No: 25-053

DAUPHIN COUNTY SUBDIVISION/LAND DEVELOPMENT REVIEW REPORT

Plat Title: David A., Daniel A. & Steven S. Straub

Project Description: Proposed subdivision for side yard addition and 1 single family dwelling.

Date: April 1, 2025 Drawing No: UP-828

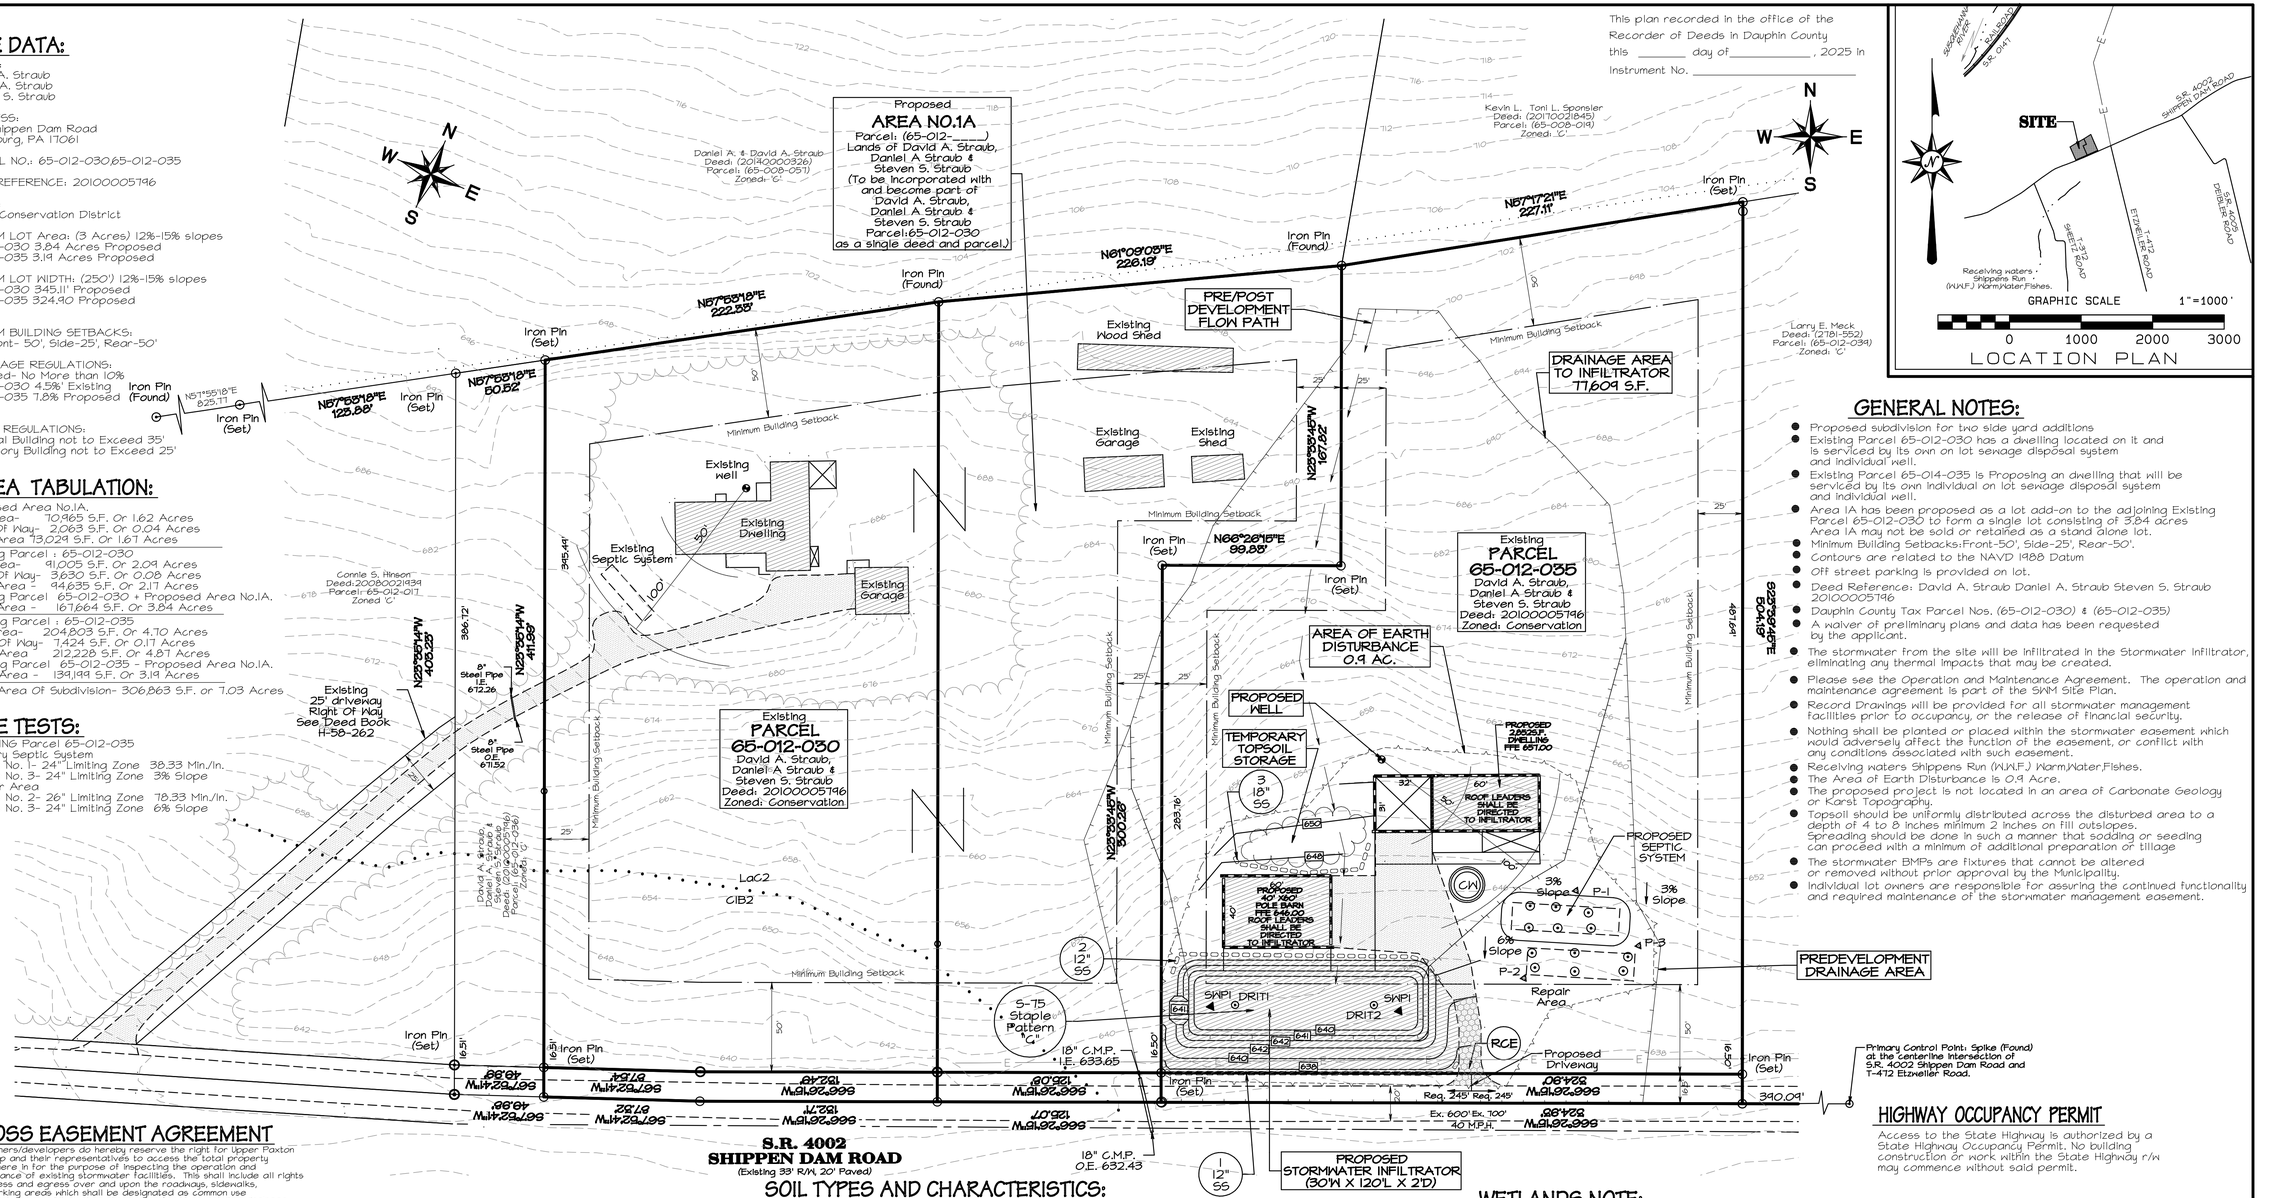
1. The location map shall be displayed at a scale of 1" = 2000'. (S-LD § 22-501.A.16 per S-LD § 22-601.A.1)
2. The plan shall be drawn to a scale of 1"=100' (S-LD § 22-601.A) There appears to be no written or graphic scale present for the plan.
3. Monuments and Markers are required to be set in accordance with Township Specifications (S-LD § 22-707.4)
4. A PennDOT Highway Occupancy Permit will be required for the proposed driveway (ZO § 27-1116.1)

1. All required signatures, certifications, dedications, and notarizations should be in place before final approval.
2. Easements and rights-of-way, if any, for streams, public utilities, or any other purpose should be displayed on the plan for reference and per the requirements set fourth in the Upper Paxton Township Subdivision and Land Development Ordinance Chapter 22.
3. There appears to be two different North Arrows for the plan (other than the one for the location map) that are in different orientations.

4. The Township should ensure that the proposed development conforms with slope requirements set forth in the Upper Paxton Township Zoning Ordinance Chapter 27. It appears there may be areas of slopes greater than 15% and greater than 25% located on both lots.
5. The primary control point could be labeled on the plan for reference.
